DCP/NRC1532  
Docket No. 52-006

**“AP1000 Design Certification Review –  
Response to Request for Additional Information”**

# AP1000 DESIGN CERTIFICATION REVIEW

## Response to Request For Additional Information

Figure 440.177-7: IRWST Injection Flow Rate

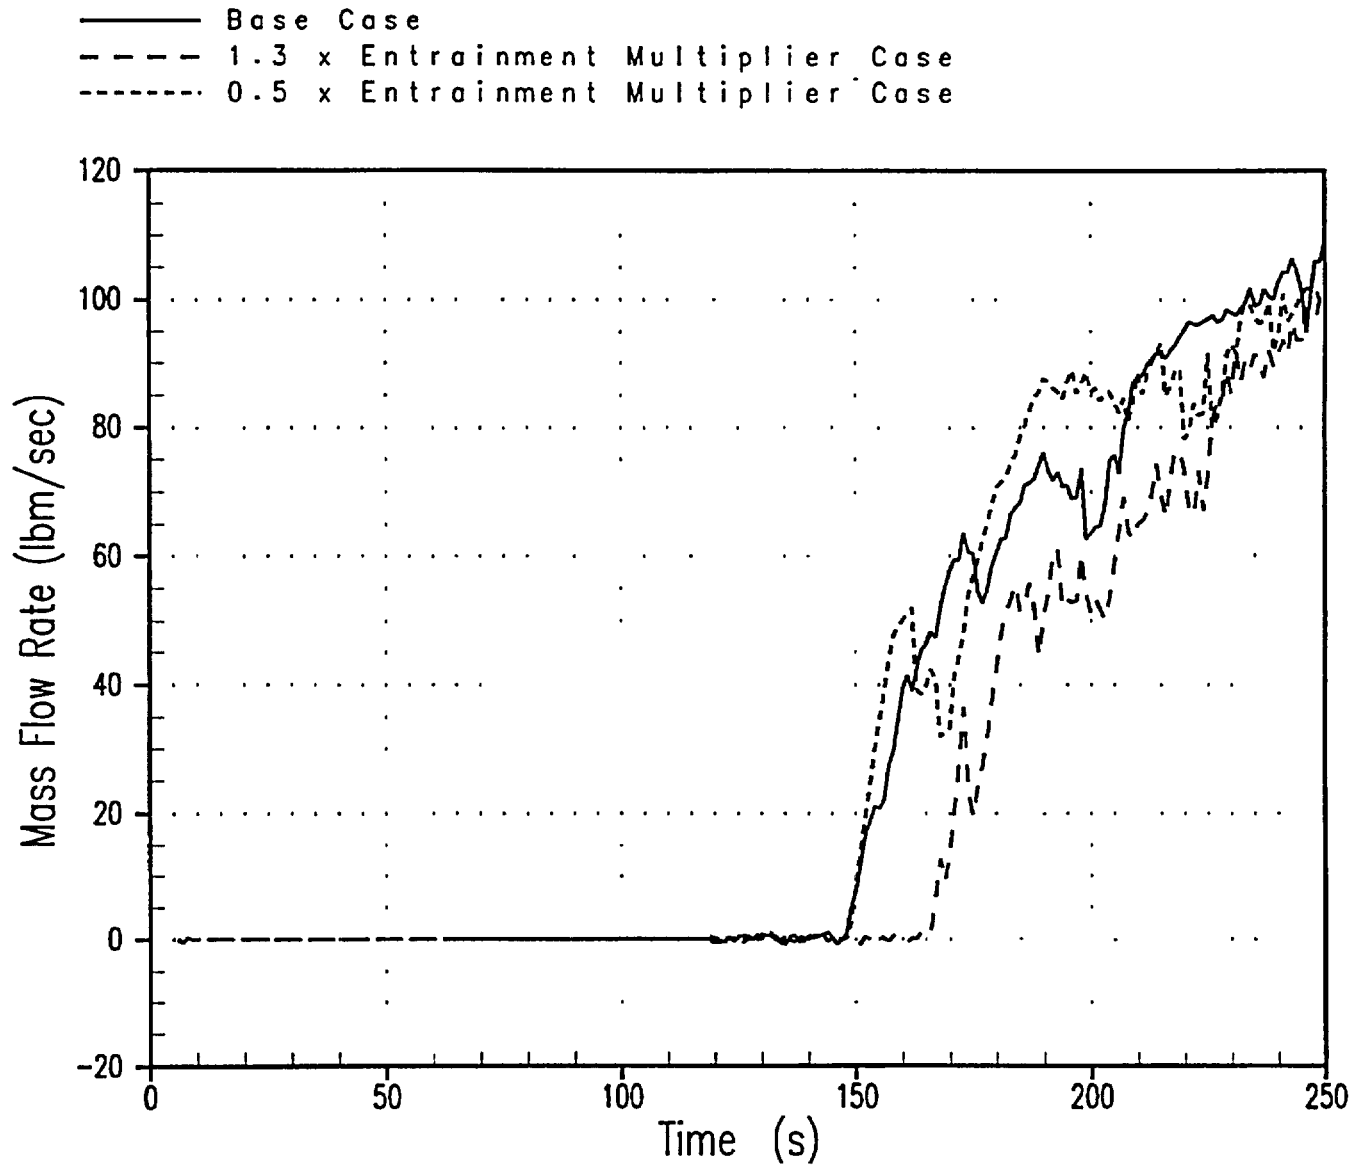
Figures C31 and C33 in Appendix A show that the core mass is underpredicted throughout the simulation, and the upper plenum mass is overpredicted by the code for the first 450 seconds or so. These figures indicate that a bias to overpredict core entrainment appears to exist when the core is quenched as well as unquenched. The requested sensitivity study is to investigate a range of core (and upper plenum) entrainment rates. Taking into account the WCOBRA/TRAC core entrainment overprediction bias, the upper range value of EMULT is selected to be 1.30, and the lower range value is selected to be 0.5 for this study.

The attached figures provide the results of sensitivity cases in which the core and upper plenum entrainment rates are multiplied by 1.3 and 0.5. The following figures may be compared with the sensitivity case(s) presented in Section A4.2:
